PREVOST

**WARRANTY
BULLETIN**

WB15-38A

DATE :	AUGUST 2015	SECTION :	23 - Accessories
EXPIRATION:	AUGUST 2017		
SUBJECT :	WASHER FLUID HOSE SUPPORT

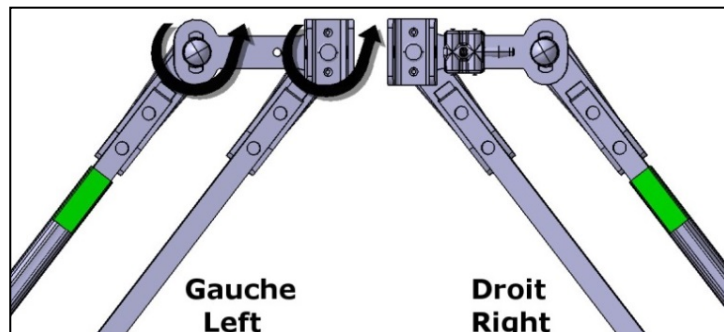
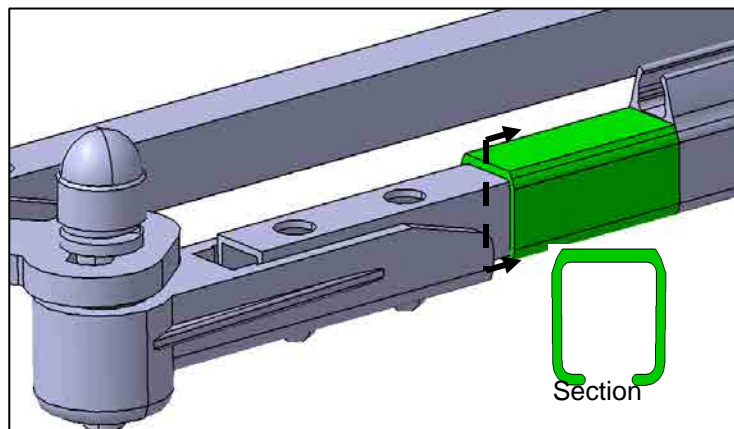
On the vehicles affected by this bulletin, add an extrusion to the wiper arms to support the washer fluid hose.

For each wiper parallelogram assembly, install one extruded spacer #300642, Qty 2 on the arm having the washing fluid hose.

Important: Orient as shown, with slot underneath.
